UNITED STATES PATENT AND TRADEMARK OFFICE

APPLICATION NO.	FILING DATE	FIRST NAMED INVENTOR	ATTORNEY DOCKET NO.	CONFIRMATION NO.
10/736,522	12/17/2003	Chi Chang Chuang	BHT-3117-175	4357
<div>7590 08/24/2007 TROXELL LAW OFFICE PLLC SUITE 1404 5205 LEESBURG PIKE FALLS CHURCH, VA 22041</div>			<div>EXAMINER CHAPMAN, JEANETTE E</div>	
			<div>ART UNIT 3635</div>	<div>PAPER NUMBER</div>
			<div>MAIL DATE 08/24/2007</div>	<div>DELIVERY MODE PAPER</div>

Office Action Summary

- 6) ☒ Other: PATENT COPY 10/ANNOTATIONS

PATENT COPY W/ANNOTATIONS

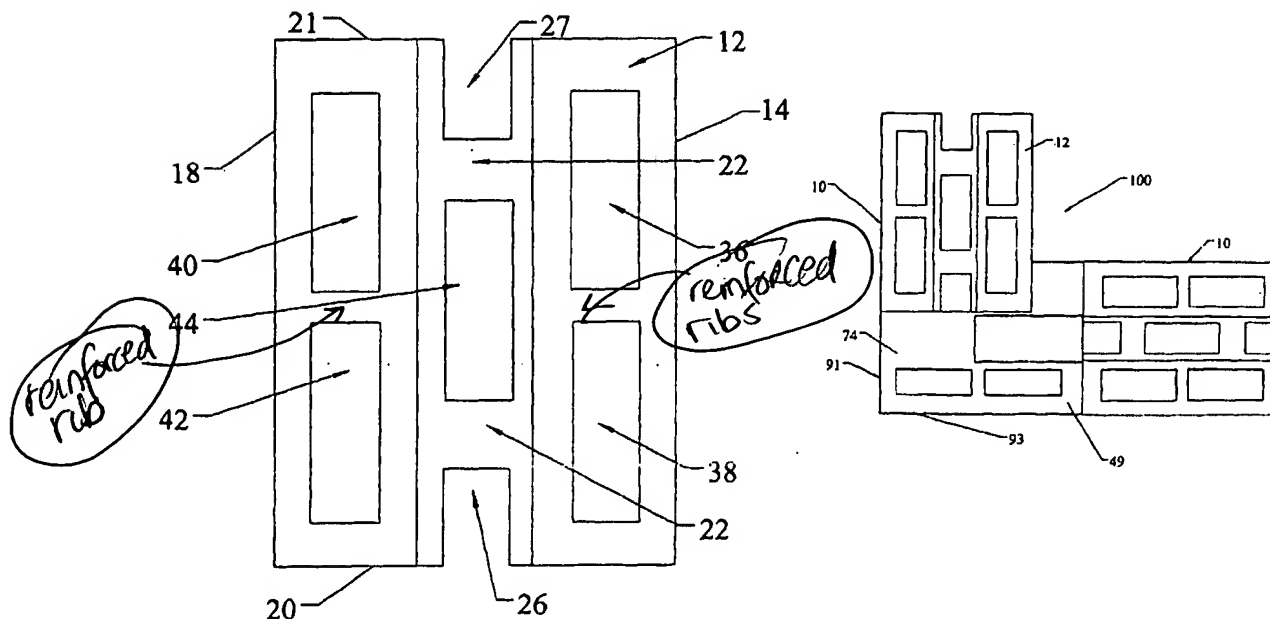
Gilbert discloses a mortarless block case with said tenons and mortises has its hollow provided on the inner walls with reinforced ribs, see annotations on patent copy preset in shape. It would have been obvious to one of ordinary skill in the art to include the ribs to strengthen the block structure.
